Access Compliance Report

Public Rights-of-Way

(Curb Ramps)

Intersection ID: 10026802	Main Street: FOREST_POINT_BV	Cross Street: N/A	Location: W
ADA ID: 102F627DE30B	Ramp Type: Perp	Initial Pass/Fail: Fail	Overall Compliance: No
Severity Score: 13.75			
Codes/Mitigation Info/Possible Solution		Field Measurements/Component Compliance

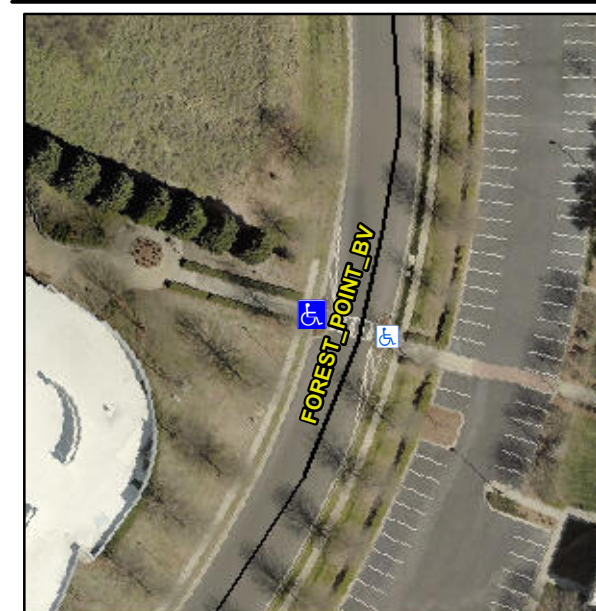
Not Found, R304.2.2

Compliance	Description	Data	Compliance	Description	Data
N/A	Ramp Length (in)	46.0	No	Ramp Slope (%)	9.5
Yes	Ramp Width (in)	48.0	Yes	Ramp XSlope (%)	2.1
N/A	Flare Type LT	N/A	N/A	Flare Type RT	N/A
N/A	Flare Slope LT (%)	N/A	N/A	Flare Slope RT (%)	N/A
N/A	Flare Traversable LT?	N/A	N/A	Flare Traversable RT?	N/A
N/A	Landing Length (in)	N/A	N/A	DWS Provided?	N/A
N/A	Landing Width (in)	N/A	N/A	DWS Contrast?	N/A
N/A	Landing Slope (%)	N/A	N/A	DWS Length (in)	N/A
N/A	Landing X Slope (%)	N/A	N/A	DWS Full Width?	N/A
N/A	Landing Curb? (Y/N)	N/A	N/A	DWS Offset (in)	N/A
N/A	Shared Landing?	N/A			
N/A	Gutter Ponding?	N/A	N/A	Gutter Slope (%)	N/A
N/A	Gutter Lip Ht (in)	N/A	N/A	Gutter X Slope (%)	N/A
N/A	Painted X Walk1?	Yes	N/A	Painted X Walk2?	N/A
	X Walk 1 Direction	To SE		X Walk 2 Direction	N/A
N/A	X Walk 1 Width (in)	98.0	N/A	X Walk 2 Width (in)	N/A
	X Walk 1 Slope (%)	3.5		X Walk 2 Slope (%)	N/A
	X Walk 1 X Slope (%)	3.6		X Walk 2 X Slope (%)	N/A

Remove & Replace Entire Ramp.
